# Access Compliance Report

## Public Rights-of-Way

### (Curb Ramps)

Intersection ID: 13468	Main Street: W_PARK_AV	Cross Street: WICKFORD_PL	Location:	N
ADA ID: 4F693F544F3D	Ramp Type: Perp	Initial Pass/Fail: Fail	Overall Compliance: No	Severity Score: 12.5
Codes/Mitigation Info/Possible Solution		Field Measurements/Component Compliance

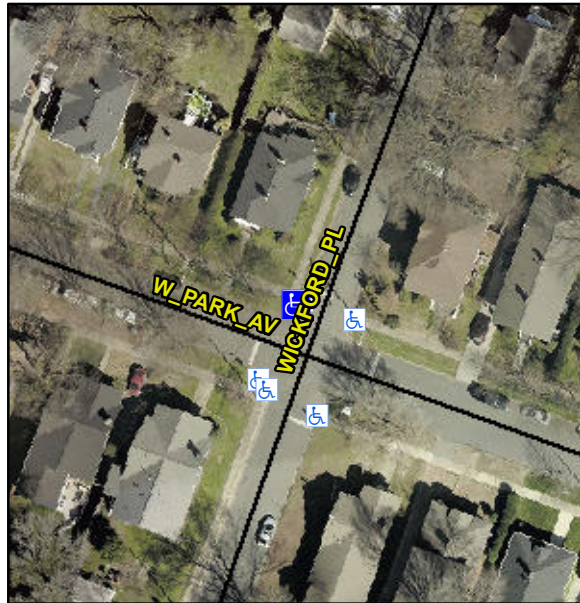
**Remove & Replace Entire Ramp.**

**Not Found, R304.2.2**

Compliance	Description	Data	Compliance	Description	Data
N/A	Ramp Length (in)	122.0	No	Ramp Slope (%)	9.6
Yes	Ramp Width (in)	60.0	Yes	Ramp XSlope (%)	0.5
N/A	Flare Type LT	N/A	N/A	Flare Type RT	N/A
N/A	Flare Slope LT (%)	N/A	N/A	Flare Slope RT (%)	N/A
N/A	Flare Traversable LT?	N/A	N/A	Flare Traversable RT?	N/A
N/A	Landing Length (in)	N/A	N/A	DWS Provided?	N/A
N/A	Landing Width (in)	N/A	N/A	DWS Contrast?	N/A
N/A	Landing Slope (%)	N/A	N/A	DWS Length (in)	N/A
N/A	Landing X Slope (%)	N/A	N/A	DWS Full Width?	N/A
N/A	Landing Curb? (Y/N)	N/A	N/A	DWS Offset (in)	N/A
N/A	Shared Landing?	N/A			
N/A	Gutter Ponding?	N/A	N/A	Gutter Slope (%)	N/A
N/A	Gutter Lip Ht (in)	N/A	N/A	Gutter X Slope (%)	N/A
N/A	Painted X Walk1?	No	N/A	Painted X Walk2?	N/A
	X Walk 1 Direction	To SW		X Walk 2 Direction	N/A
N/A	X Walk 1 Width (in)	N/A	N/A	X Walk 2 Width (in)	N/A
	X Walk 1 Slope (%)	5.4		X Walk 2 Slope (%)	N/A
	X Walk 1 X Slope (%)	3.3		X Walk 2 X Slope (%)	N/A
